**SAN DIEGO GAS & ELECTRIC COMPANY  
SOUTHERN CALIFORNIA GAS COMPANY  
PIPELINE SAFETY & RELIABILITY PROJECT (PSRP)  
(A.15-09-013)  
(7<sup>th</sup> DATA REQUEST FROM THE SIERRA CLUB)**

**Date Requested: March 17, 2017  
Date Responded: March 31, 2017**

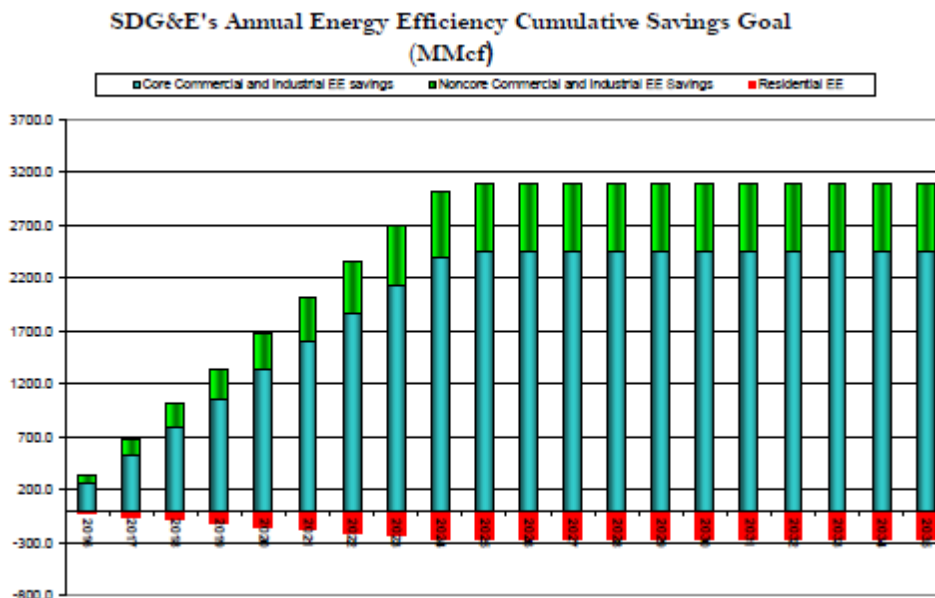
Response to Sierra Club Data Request 9 states that “The 2016 CGR assumes that energy efficiency programs will continue to be funded after the year 2024. Accordingly, the established energy efficiency goals for the year 2024 are incorporated into the forecasts for the years 2025-2035.” However, the graph on page 118 of the 2016 CGR, excerpted below does not appear to show any increase energy efficiency savings from 2025 onward. Given the apparent lack of additional efficiency savings, please answer the following:

- a. What specific amount of annual program funding is assumed from 2025 to 2035?
- b. What amount of additional energy savings does this funding achieve?
- c. Why this continued funding does not appear to correlate to similar increases in efficiency savings as indicated for years 2016-2024.

- 
- a. The 2016 CGR does not assume a specific amount of annual program funding from 2025 to 2035. Rather, it assumes that the established energy efficiency goals for the year 2024 will continue in subsequent years.
  - b. Please see the response to Question 5(a) above.
  - c. The graph on page 118 of the 2016 CGR was based on earlier forecasts of energy efficiency savings. Subsequent to the preparation of these forecasts, revised energy efficiency forecasts were developed. These revised energy efficiency forecasts were then used in preparing the final 2016 CGR forecasts. Inadvertently, the graph on page 118 of the 2016 CGR was not updated. The attached data and graph correspond to the revised energy efficiency forecasts. This information supersedes the information contained in the graph on page 118 of the 2016 CGR.

The revised graph in the attachment shows increases in efficiency savings through year 2033 that are similar to those in the period 2016-2024. The reason why these increases cease is explained below.

For a period of time, as prior program year measures fall out of the forecast each year, they are replaced with new measures that have higher energy efficiency savings goals. This results in increased energy efficiency cumulative savings goals over the period. Because the established energy efficiency savings goals for 2024 are assumed to continue into the future at the same 2024 level, new measures are expected to have the same energy efficiency savings goals as the expiring measures beginning at some point. This occurs in the year 2033, as indicated by the leveling off of the energy efficiency cumulative savings goals in the attached graph beginning at the year 2033.
